CONSTRUCTION BULLETIN 13-03

Masonry Sound Wall Structural Detail Updated

To alert construction personnel of an updated detail for masonry sound barrier wall construction.

Background

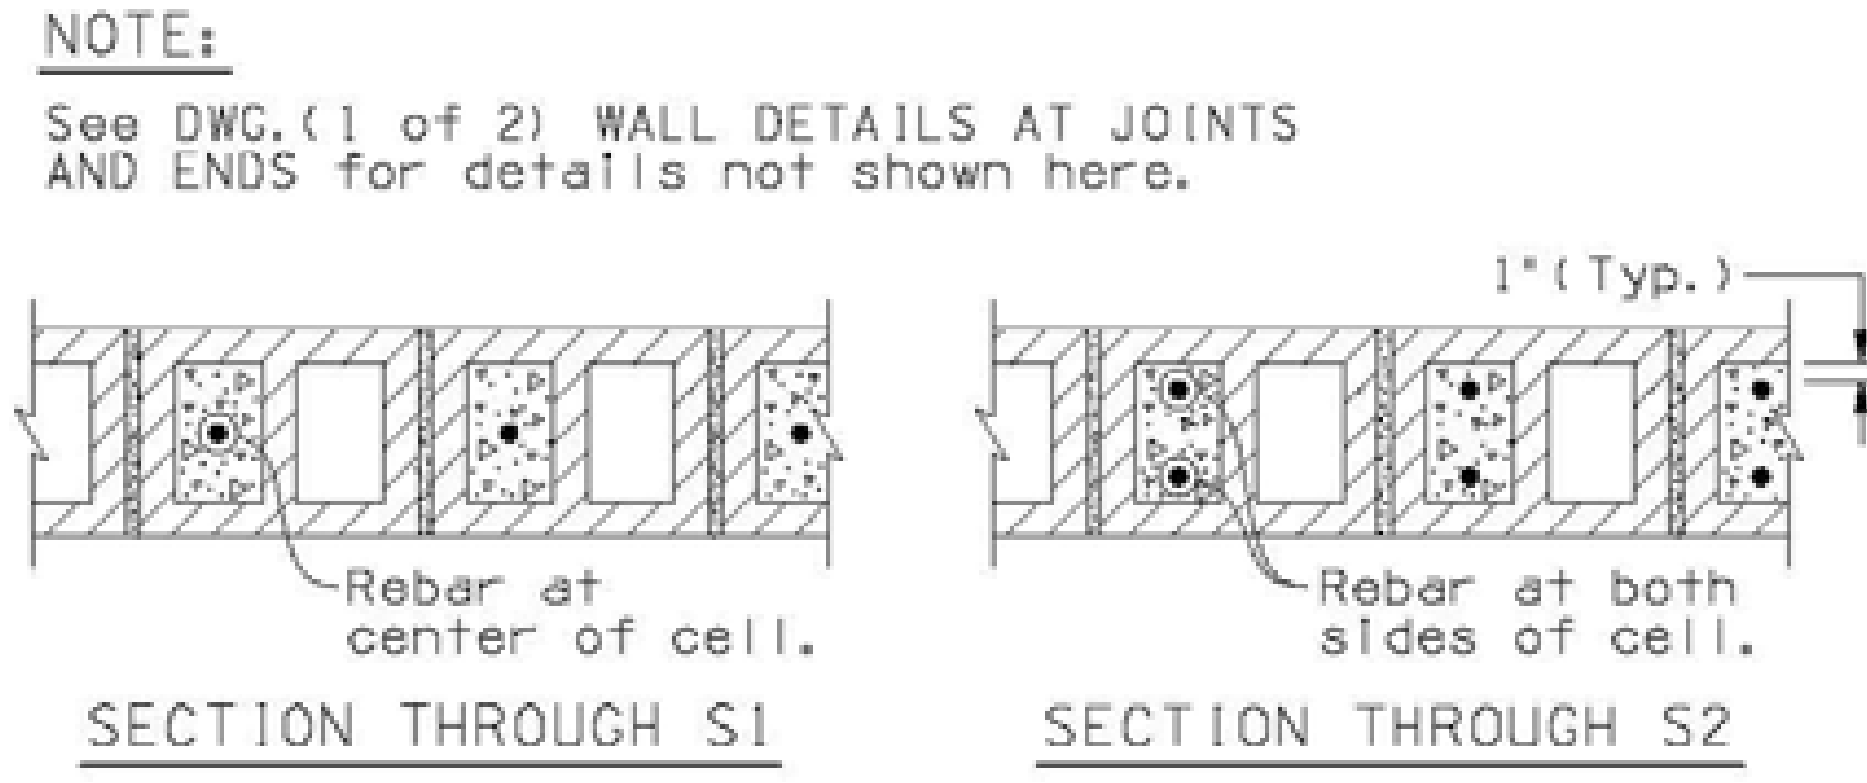
The Department has experienced inconsistency in the detailing and construction of masonry sound barrier walls at angle points. The lack of a continuous bond beam and running bond resulted in some minor separations at wall angle points. To ensure consistency with joint workmanship, a typical section at the wall angle point was incorporated into Structure Detail Drawing [SD 8.02-2](#). Designers were informed of the update January 23, 2013 through issuance of [Bridge Bulletin 2013-1](#).

NO	DESCRIPTION OF REVISIONS	DATE
1	Original Issue	4-03
2	Revised Reinforcing, General Update	02-07
3	General Update	1-10
4	Added Details for Conn. to Conc. Rd. and Ret. Wall Point	01-13

It is anticipated this change will apply to very few ongoing projects; a procedural change order should be executed for applicable projects. It is not required to correct wall angle points where construction has been completed, however such locations should be inspected for proper workmanship.
